Work Order ID 75945

Item Name: Crosstube Turning Detail

<b>DART AEROSPACE LTD</b>		<b>Work Order:</b> 75945
<b>Description:</b> Crosstube Assembly (205/212 Low Aft)		<b>Part Number:</b> D212-664-247
<b>Inspection Dwg:</b> D212-664-247 Rev: B		<b>Page 1 of 1</b>

DRAWING NO. D212-664-247	TITLE CROSSTUBE ASS'Y (205 LOW AFT)	REV. B	<b>DART AEROSPACE LTD ENGINEERING ORDER</b>		D.E.O. NO. D212-664-247-B-1	SHEET NO. SHEET 1 OF 1	SCALE NTS
DRAWN <i>q</i>	CHECKED <i>ASS</i>	MFG. APPR. <i>AB</i>	APPROVED <i>MD</i>		DE APPR. <i>MD</i>		
DATE 11.07.15	DATE 11.07.20	DATE 11.07.21	DATE 11/07/21		DATE 11.07.21

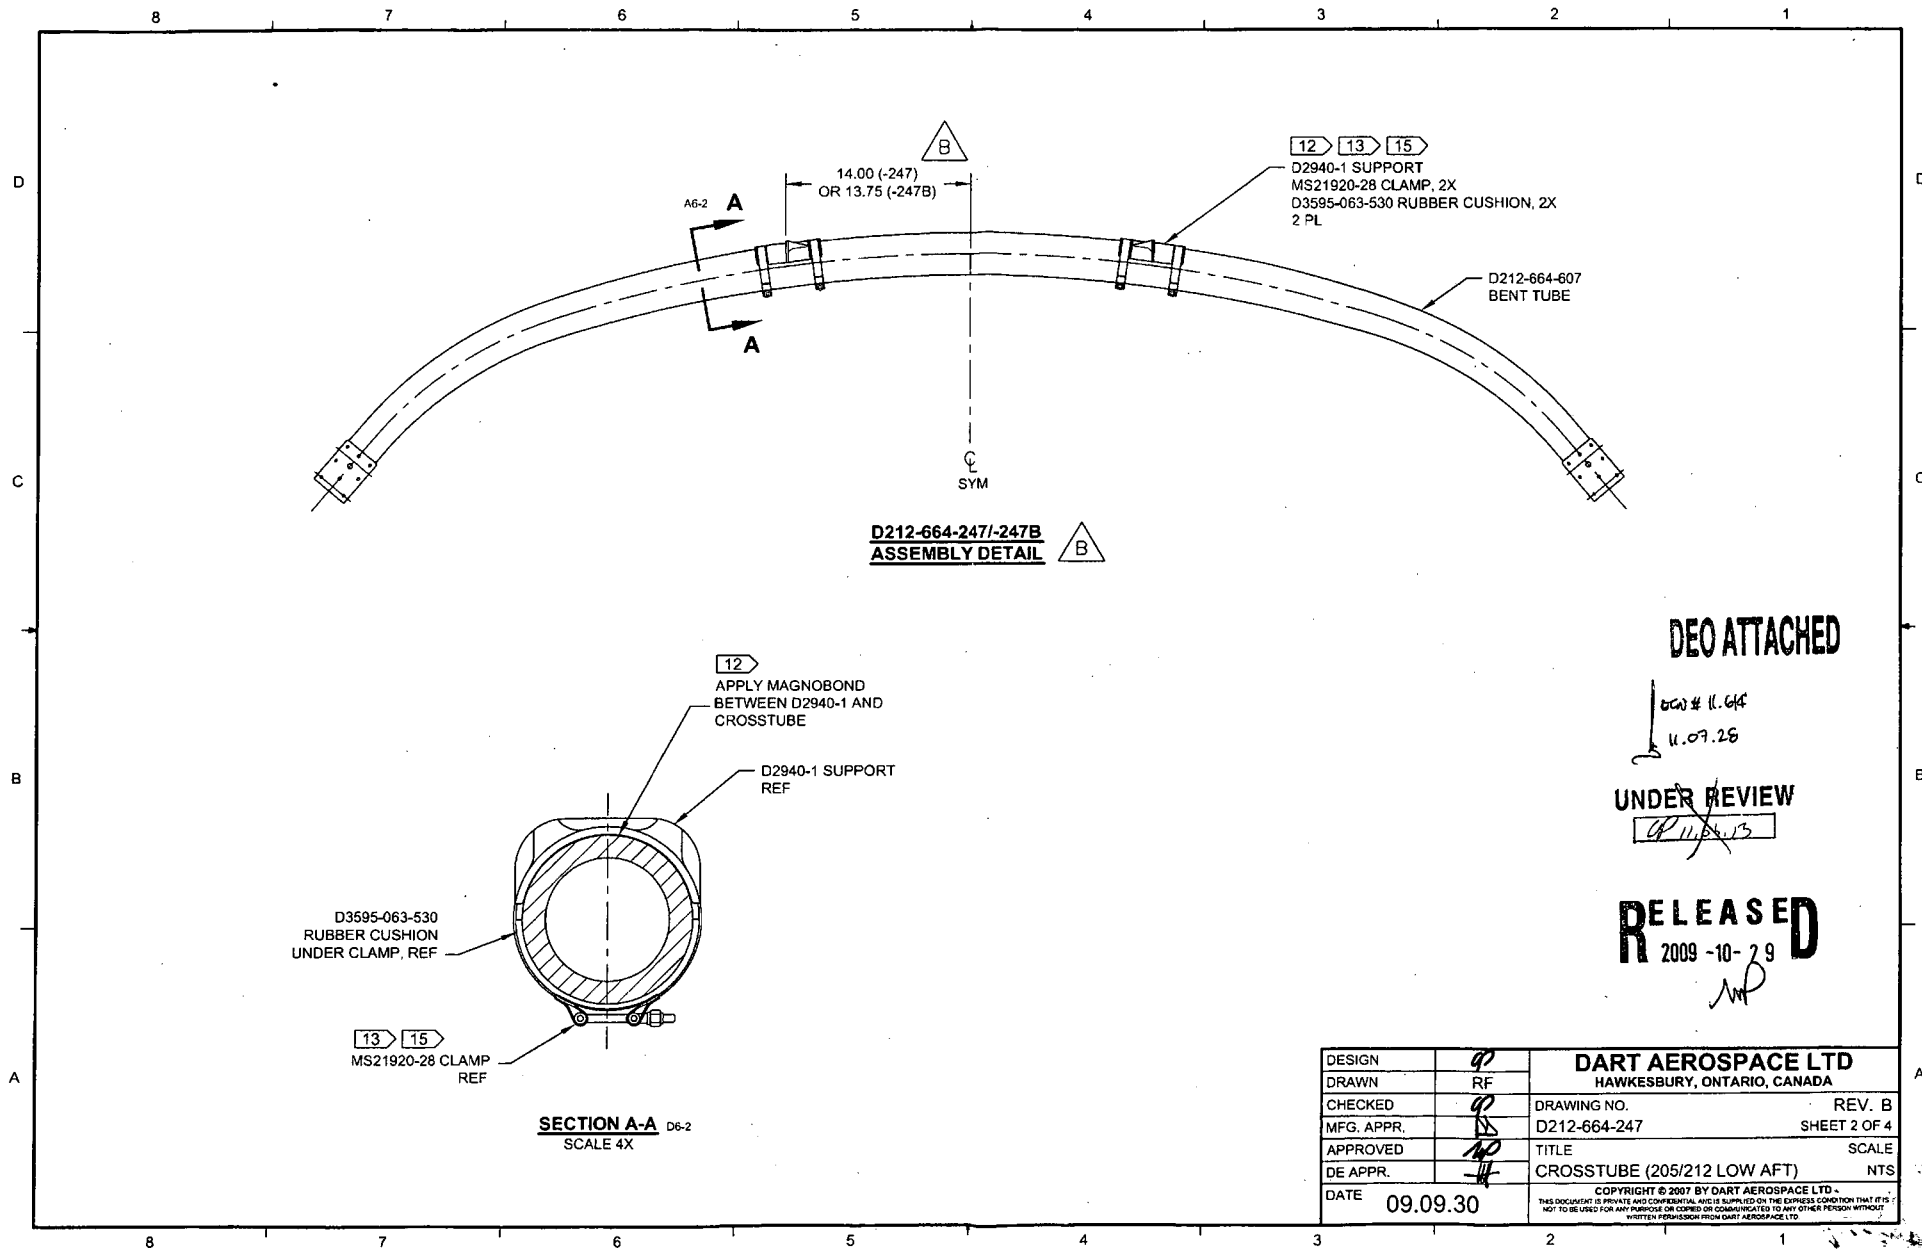
**PURPOSE:**

REPLACE MAGNOBOND WITH PROSEAL.

NOTE 12 & 15, SHEET 1 IS AMENDED AS FOLLOWS:

- 12) INSTALL D2940-1 SUPPORT USING 0.03" TO 0.06" THICK LAYER OF MAGNOBOND 6398 TO THE SURFACE OF D2940-1 THAT WILL BE IN CONTACT WITH THE CROSSTUBE PER QSI 015. LET CURE FOR 12 HOURS AFTER INSTALLATION AND PRIOR TO PACKAGING.
- 15) TORQUE CLAMPS 80 TO 100 IN-LB. ENSURE AT LEAST 1.5 THREADS SHOWING IN SAFETY AND THAT NUT HAS NOT BOTTOMED-OUT AFTER TORQUING.

- 12) TO INSTALL D2940-1 SUPPORT: ABRASE MATING SURFACE OF SUPPORT AND CROSSTUBE WITH 180-GRIT SANDPAPER AND REMOVE RESIDUE WITH MEK (OR EQUIVALENT). APPLY A 0.04" TO 0.07" THICK LAYER OF PROSEAL 890 CLASS B-2 (OR AMS-S-8802 CLASS B-2) SEALANT TO MATING SURFACE OF SUPPORT.
- 15) TORQUE CLAMPS 80 TO 100 IN-LB. ENSURE AT LEAST 1.5 THREADS SHOWING IN SAFETY AND THAT NUT HAS NOT BOTTOMED-OUT AFTER TORQUING. **PRIOR TO PACKAGING, RE-CHECK TORQUE ON CLAMPS AFTER PROSEAL 890 SEALANT HAS CURED FOR 72 HOURS.**
